Manning Equipment, LLC
 12000 Westport Road * Louisville, KY. 40245

IMPORTANT NOTICE!
SERVICE ADVISORY #MESA072413

Subject: Exhaust Extension, Warning Decal, & Drain Plugs

Models Affected: 2012 Ford F350-550 Super Duty Cab Chassis with (DRW), Gas Engine / Service Body Application.

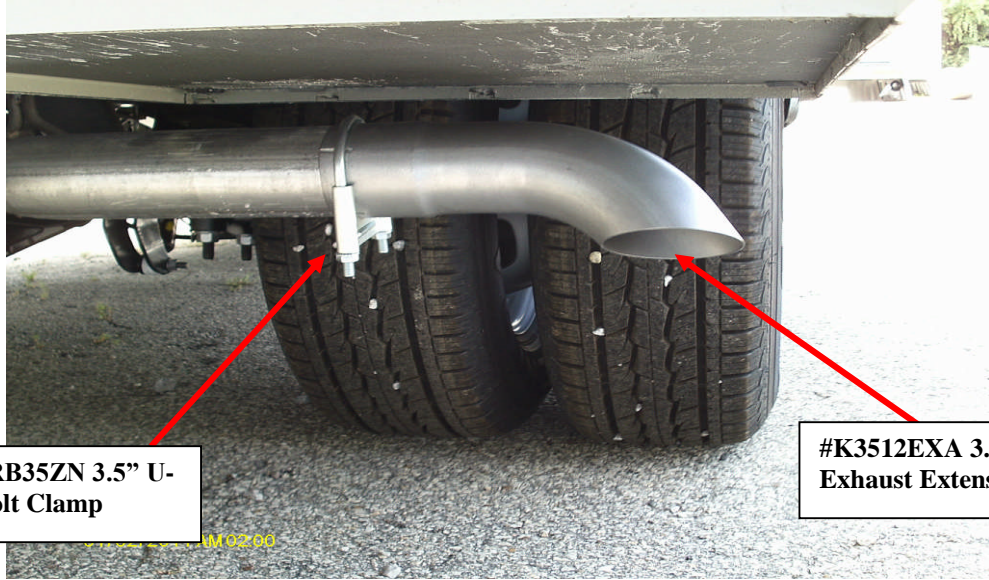
Manning Equipment, LLC has decided those units up-fitted with Service Bodies on Ford Super Duty chassis with dual rear wheels and gas engine and were built October 10, 2011 through June 29, 2012 will require an exhaust extension to redirect the exhaust spray down and away from the service body compartment floor. The exhaust spray on some of these vehicles was discoloring paint and/or primer in the lower floor area and damaging the plastic drain plugs in compartment floor above the exhaust. In one instance a fire was reported due to the improper storage of flammable material in the compartment above the exhaust.

Manning Equipment has identified the above unit that was shipped to your facility and should apply to this Service Advisory for exhaust spray at right rear compartment. Manning Equipment will furnish at no charge an Exhaust Extension, U-bolt clamp, Warning Decal, and Drain Plugs for your unit. Please call, fax, or email me at below and confirm that this unit is still at your facility. I will require a ship to address, POC (Point of contact), and a phone number. After I receive this information Manning will ship the above components for installation on your vehicle to your specified location. If for some reason you are not able to install these components you may take your truck to the closest Truck Center in your area to have these components installed. Manning will pay up to (1) hour labor for this repair, please have the Truck Center phone me for direct payment.

#K3512EXA 3.5" x 12" Exhaust Extension

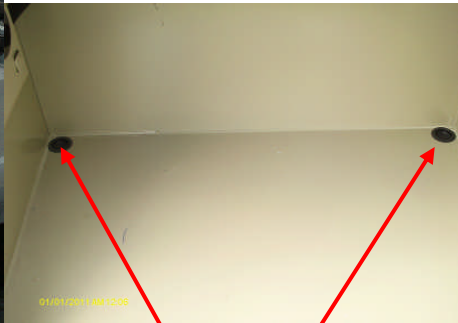
**Danger Decal
#ME32070312SBDL**
Install Inside rear compartment door upper right hand corner.
Note: If body is up fitted with two compartments at the rear, decal must be installed in the compartment closest to the truck exhaust pipe.

**Plastic Drain Plugs
(Inside Compartment)**
Replace if necessary
